Sunset Beach Imp.

Subject: Finding of No Significant Impact
Proposed Beach Improvement at Sunset Beach Park
Oahu, Hawaii
Tax Map Keys 5-9-01: Pors. 37 & 38; 5-9-02 Por. 72
and Ke Nui Road/Hoalua Street Remnant
First Division

FINAL ENVIRONMENTAL ASSESSMENT

SUNSET BEACH IMPROVEMENTS

Figure 3
PROPOSED IMPROVEMENTS

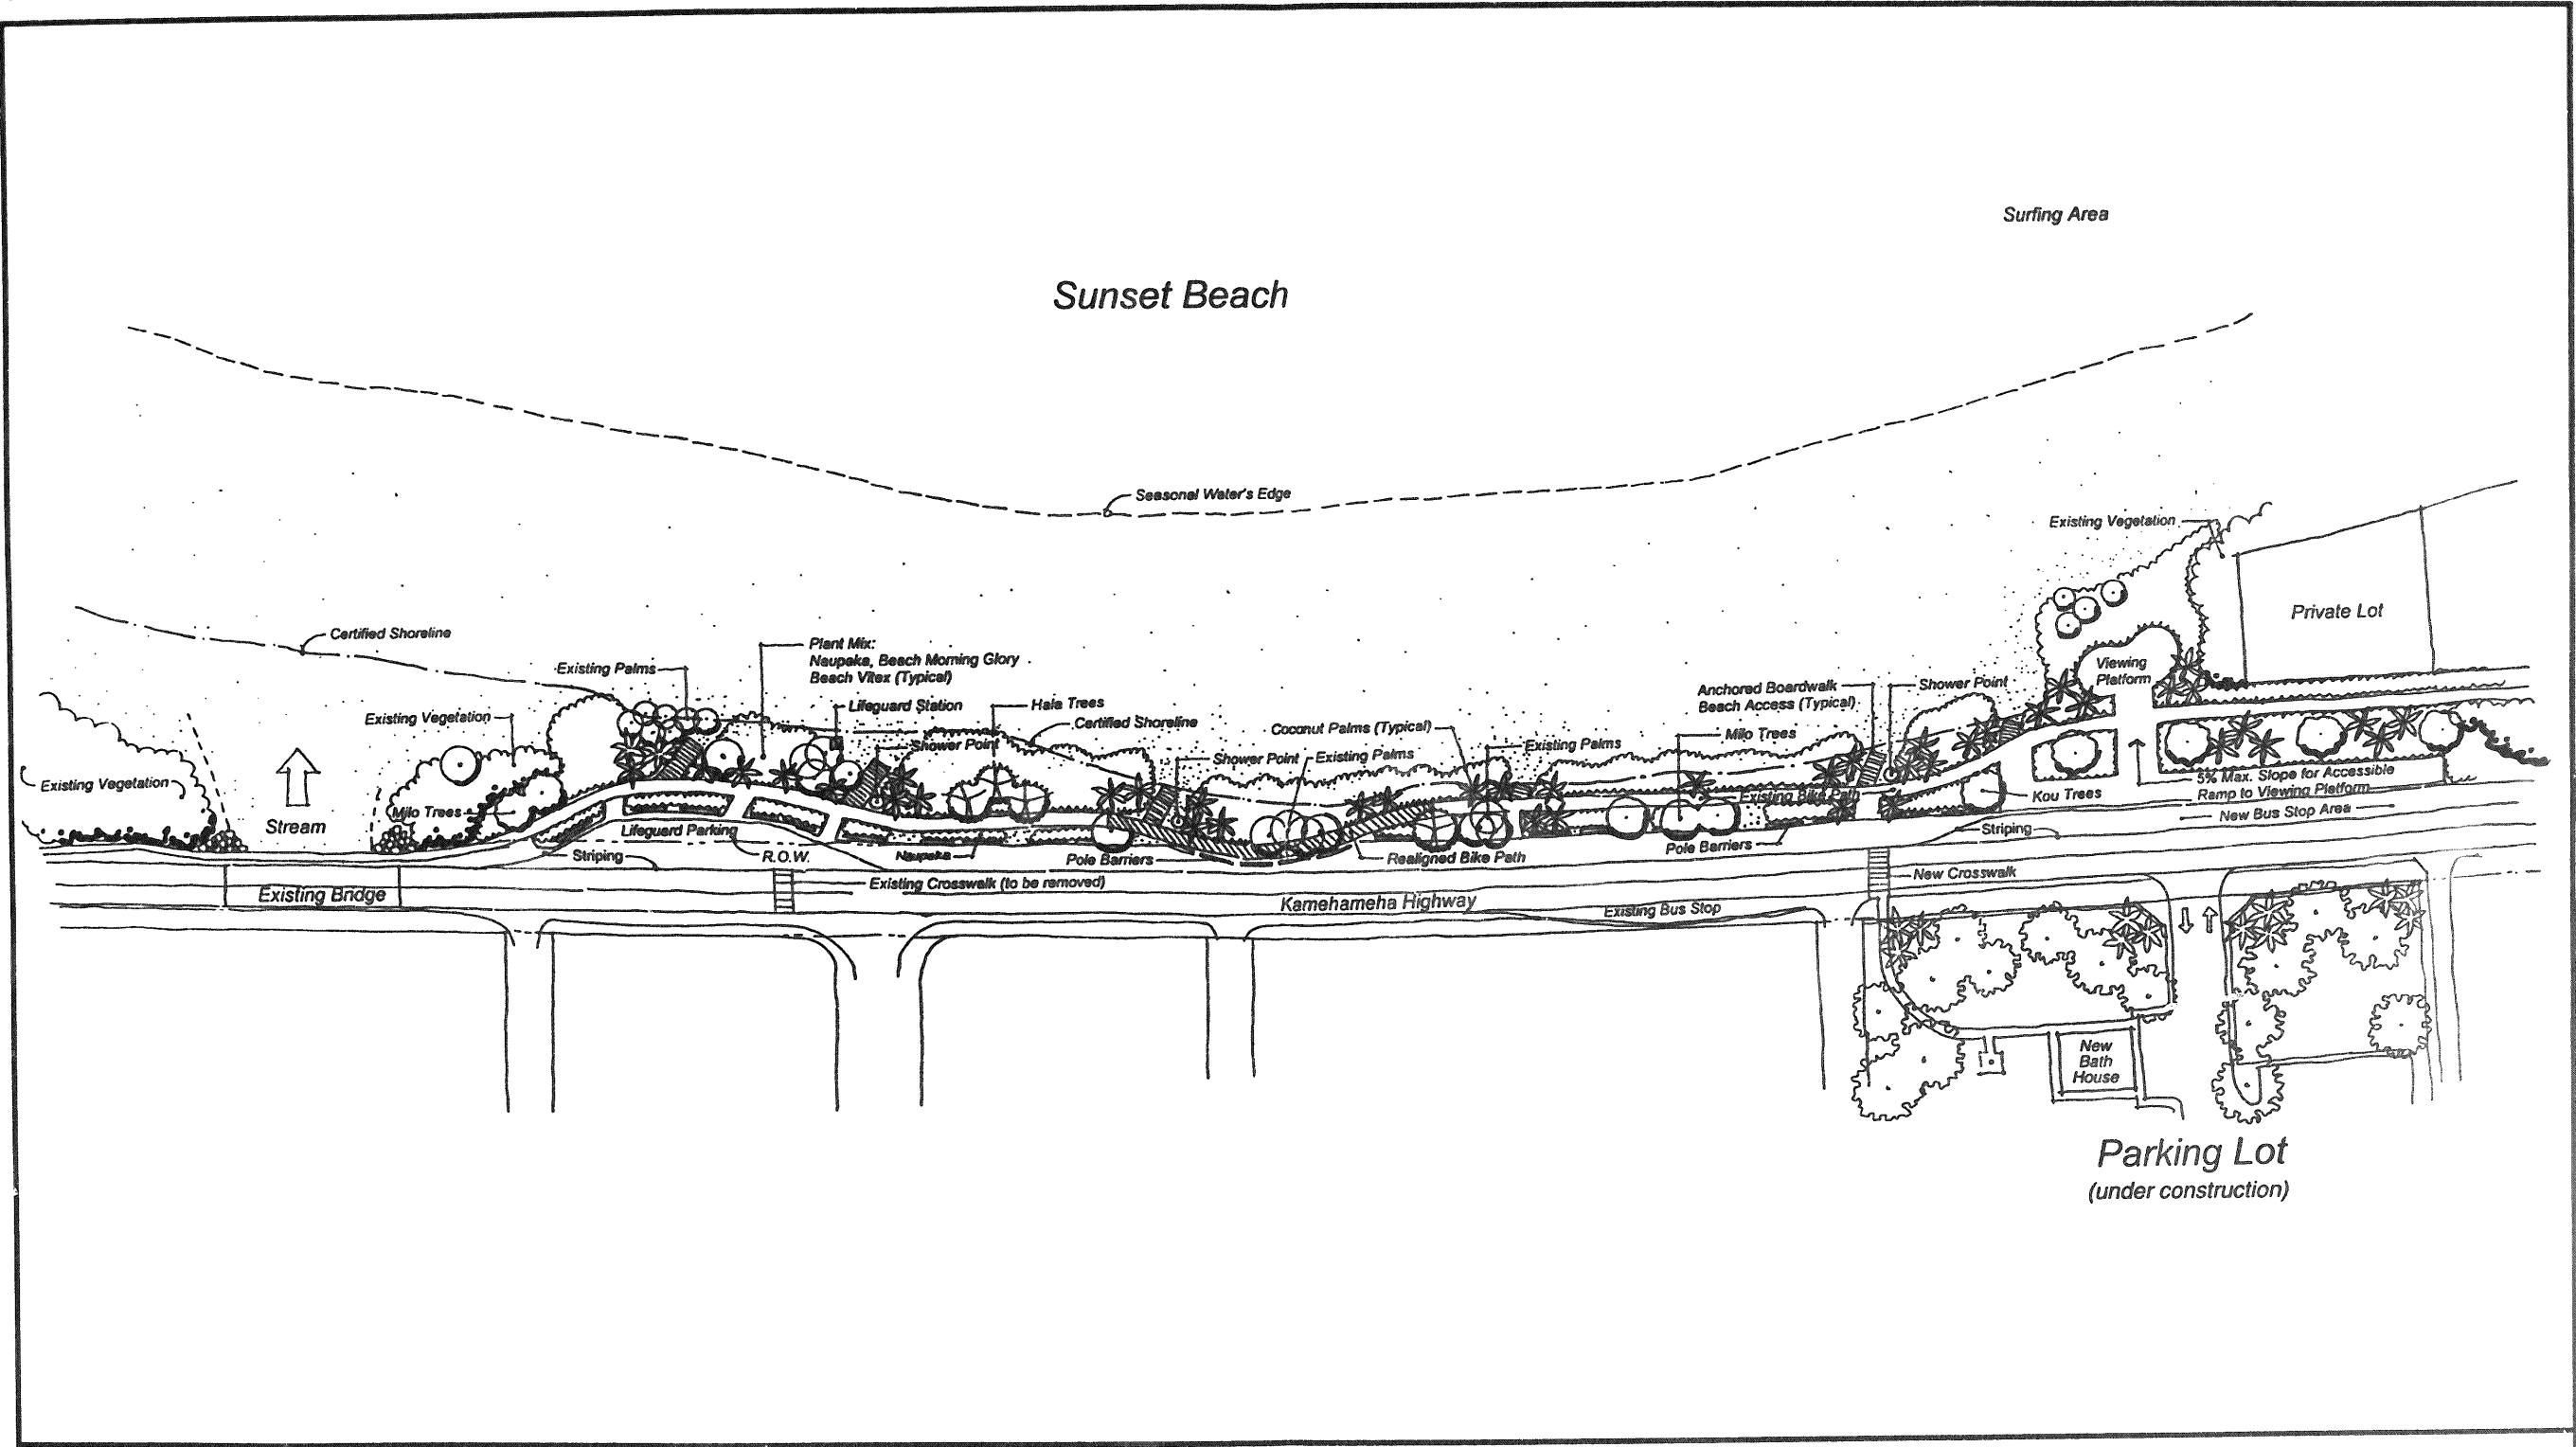
3. The EA states that there will be four outdoor showers. Only one shower is shown on Figure 3. The other three showers should also be depicted on the site plan.

Figure 4
AERIAL PHOTO OF PROJECT SITE
 SUNSET BEACH IMPROVEMENTS
 Koolauloa, Oahu, Hawaii

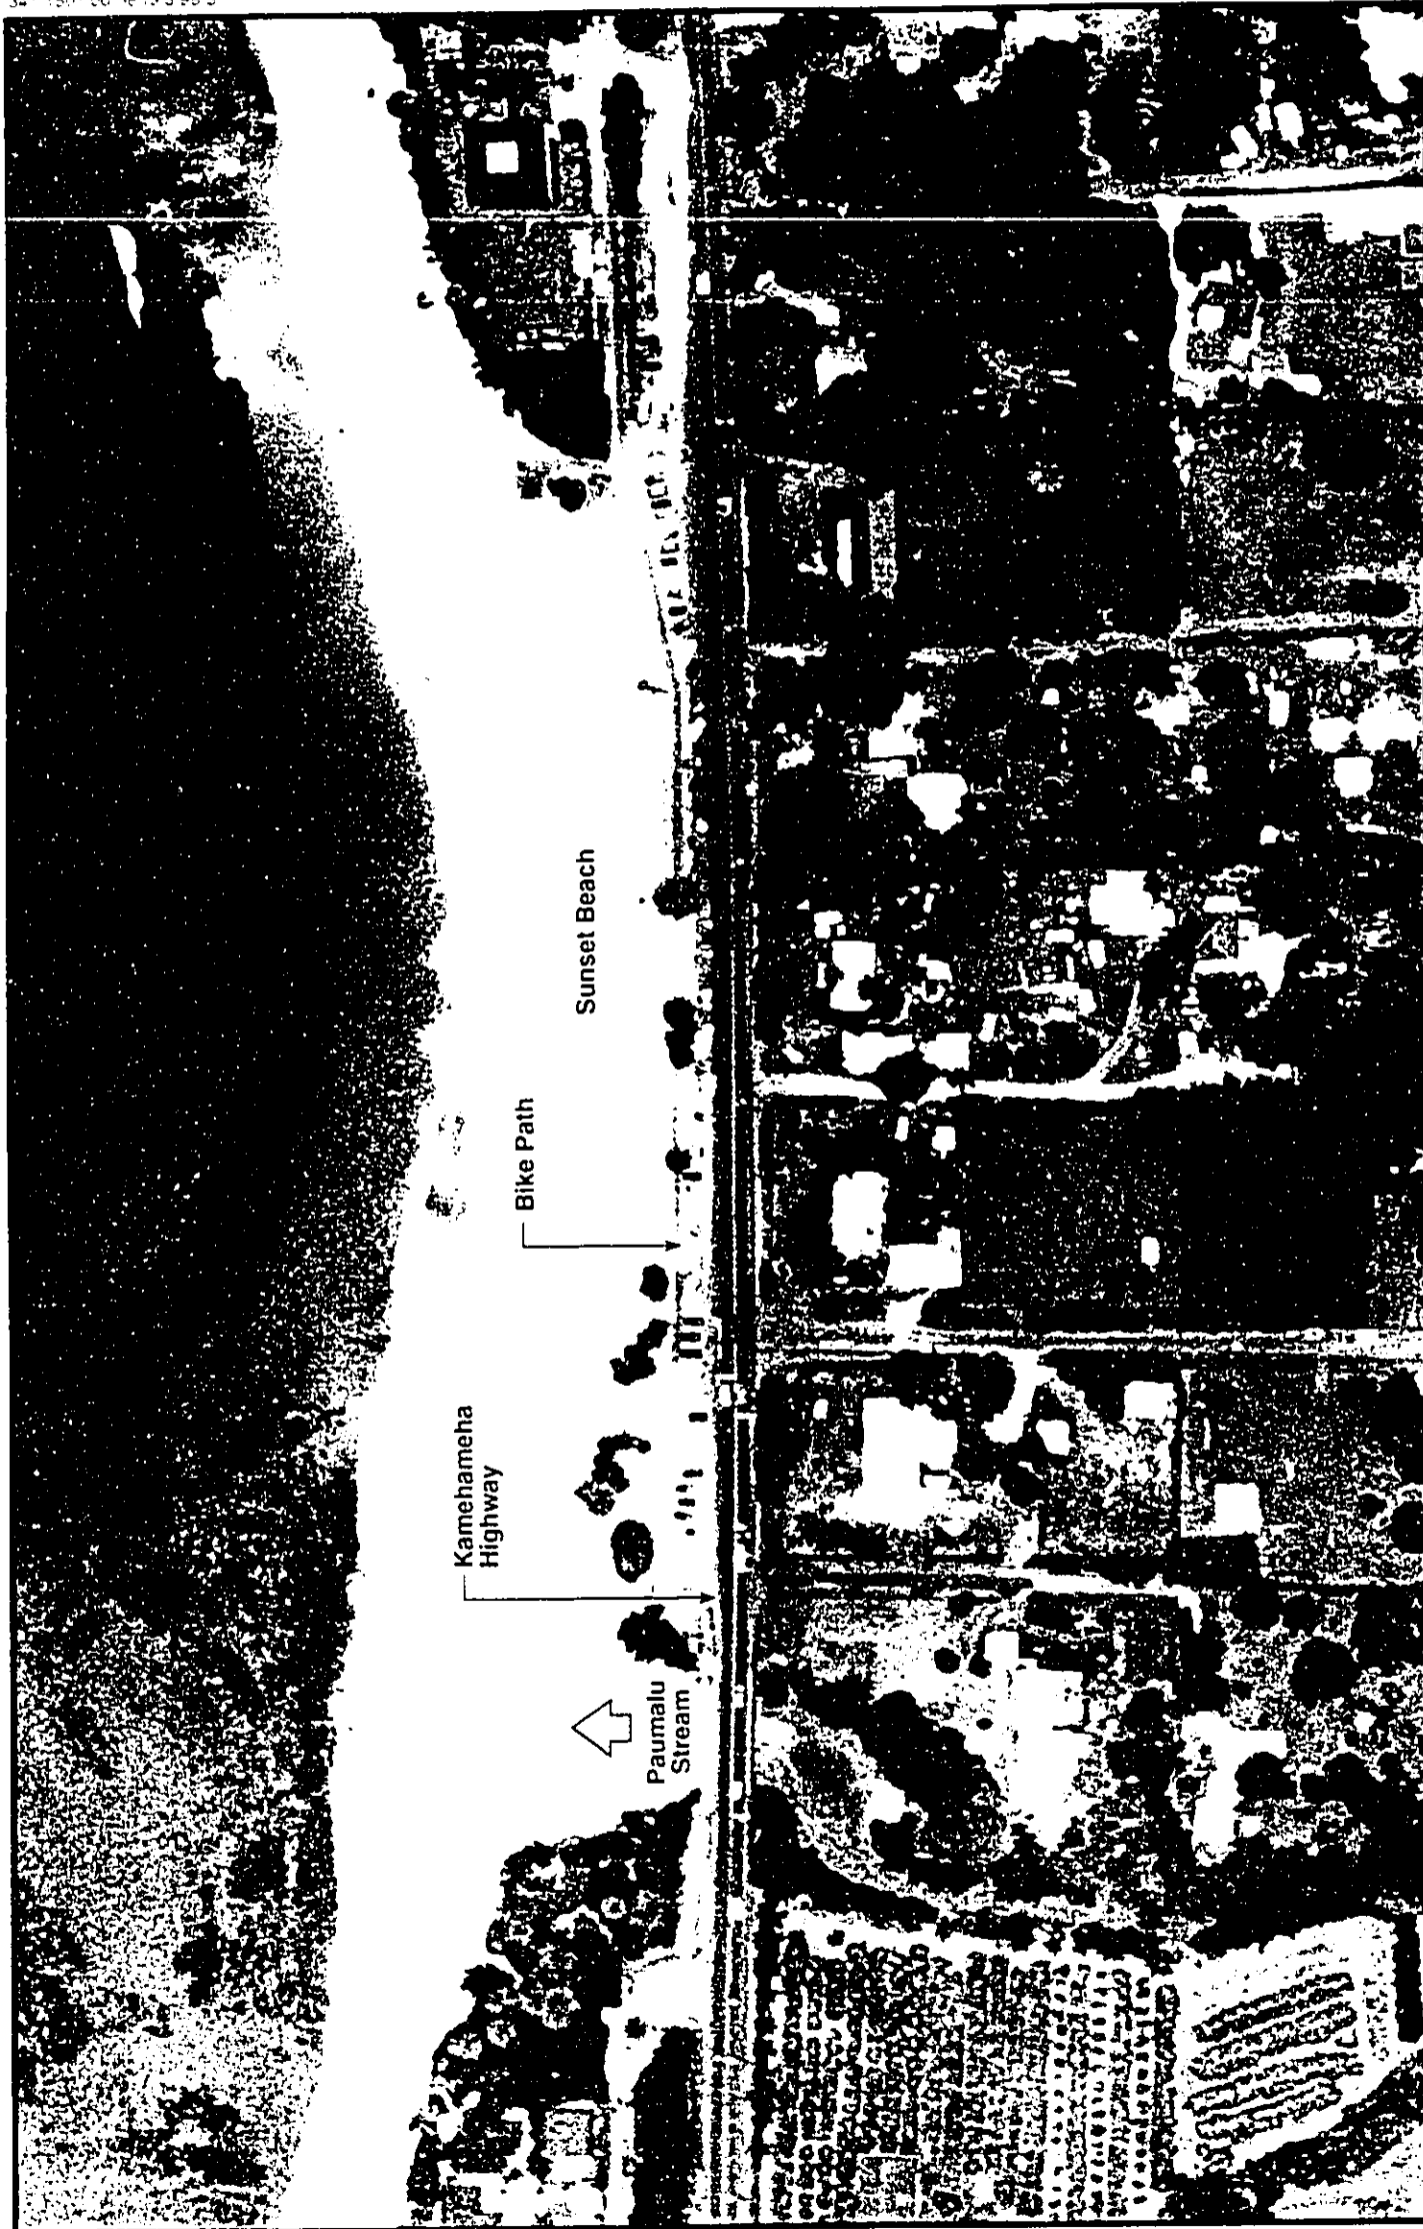
Page 11: Where are sites 50-80-01-5585 and -5586? Please indicate their locations on Figure 4.

Figure 6
BEACH PROFILE
SUNSET BEACH IMPROVEMENTS
Koolauloa, Oahu, Hawaii

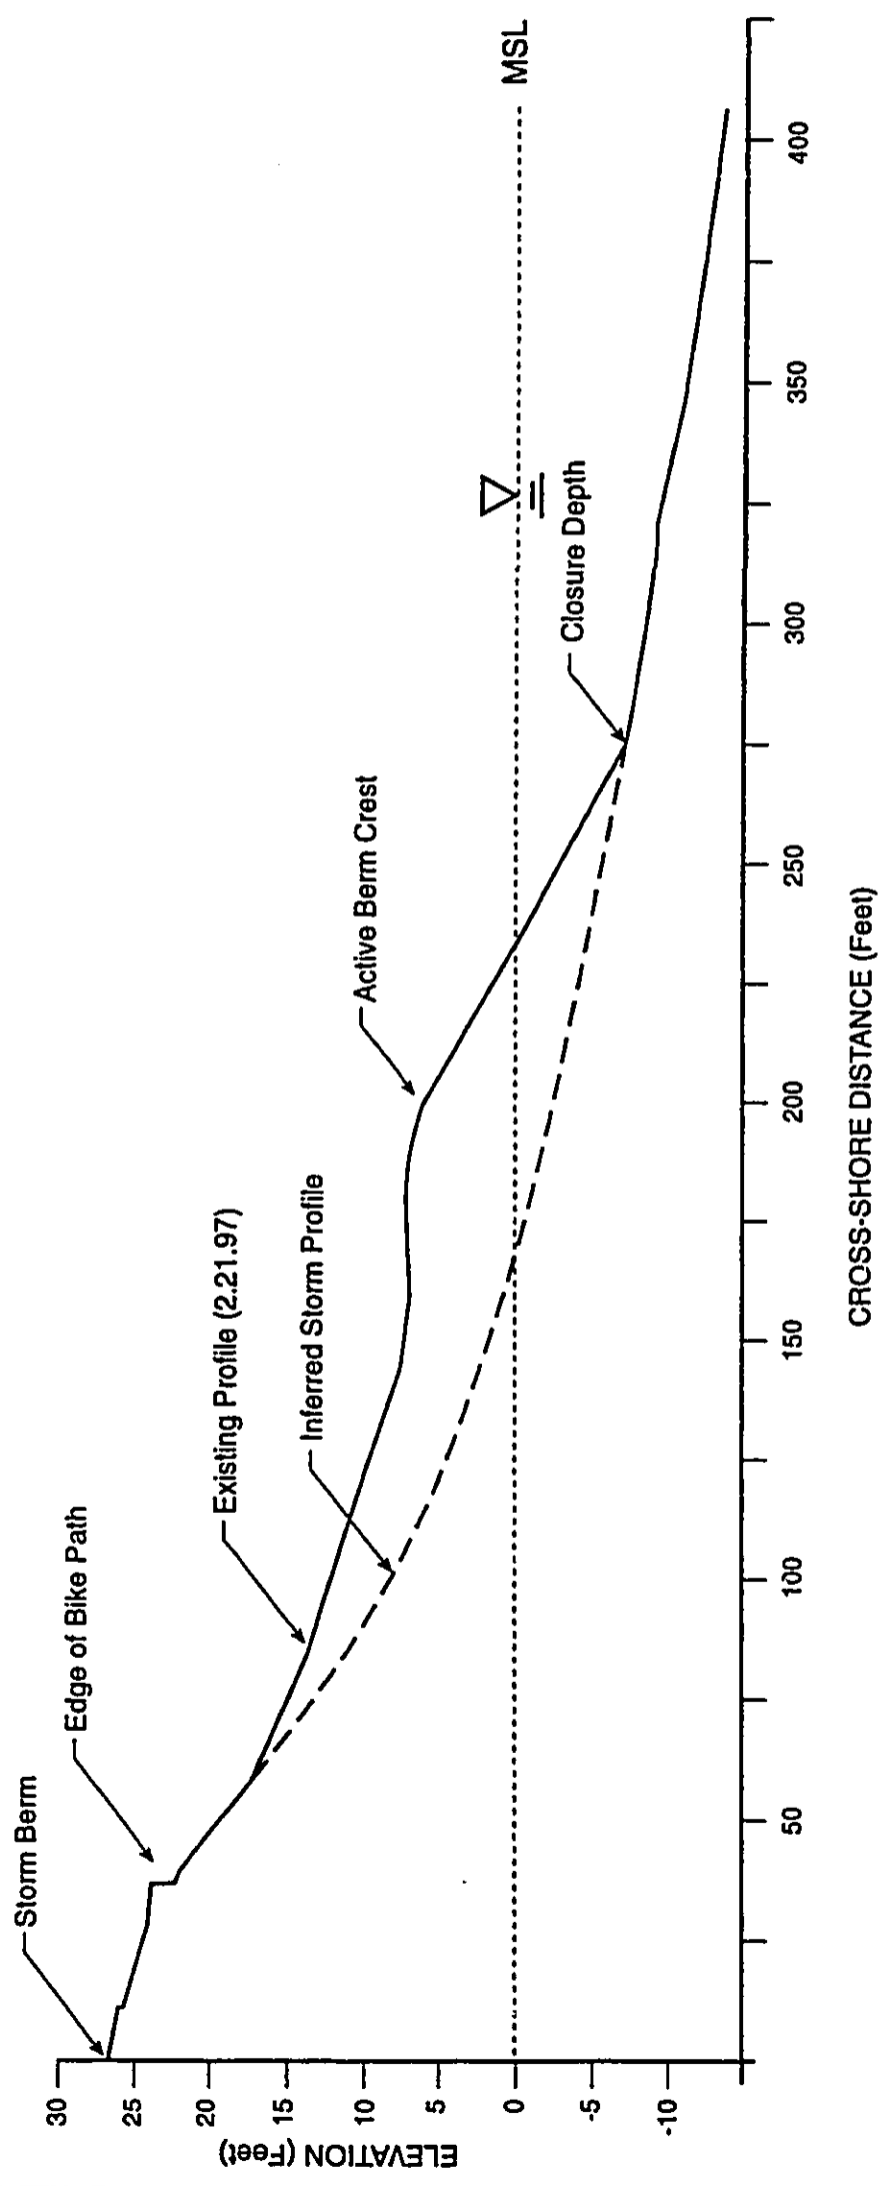
8. On Figure 6 of the Draft EA, a storm berm and active berm crest are identified. The mauka storm berm is identified as the area between these two berms just below the makai edge of the bike path. The volume of sand that would be moved is difficult to estimate since it will depend on the pre-maintenance condition and desired profile of the beach. Also, the amount of sand to be
